Affidavit

- 1. My firm was employed to prepare a plat recorded as Creek View Meadow Plat 1, recorded August 6, 2002 as Entry No. 8314284 in Book 2002P at page 208 of the official records of the Salt Lake County Recorder.
- 2. Said plat shows a 10 foot drainage and public utilities easement around the perimeter of each lot. On the following lots the 10 foot drainage and public utilities easement has also been designated as a sidewalk easement to accommodate a meandering sidewalk:

CREEK VIEW MEADOWS PLAT EXHIBIT A

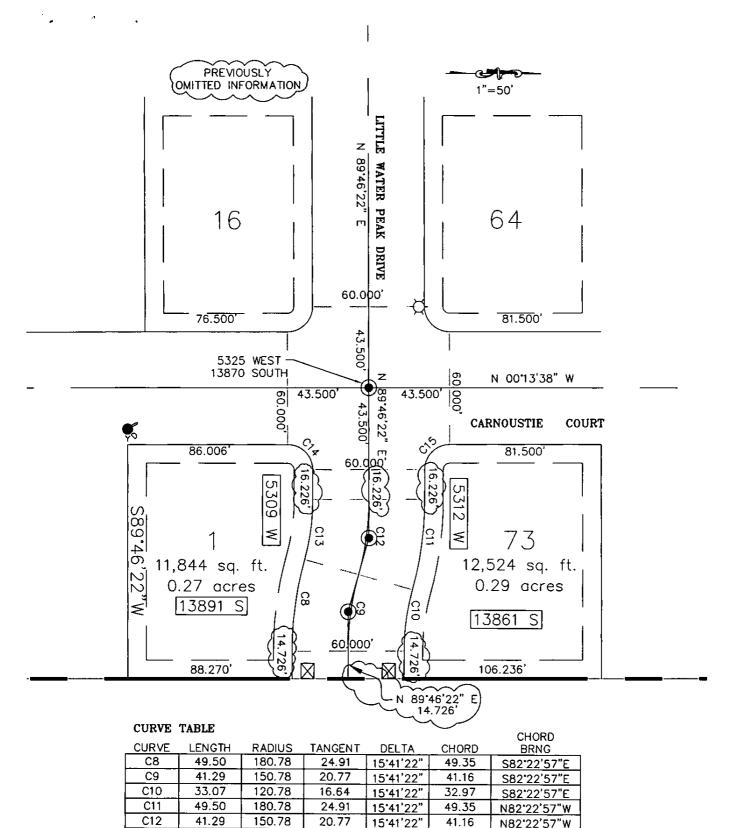
- 3. Due to conflicts with the installation of dry utilities, the 10 foot utility easement will be increased to a 15 foot utility easement along the front of each of the lots noted specifically in item 2.
- 4. The following 2 (two) lots are missing dimensioning information along the front lot lines on Little Water Peak Drive.

Centerline dimensioning is also missing on Little Water Peak Drive between Lot 1 and Lot 73.

5. Exhibit A shows the dimensioning information that was omitted on Lot 1 and Lot 73 and the omitted centerline dimensioning on Little Water Peak Drive.
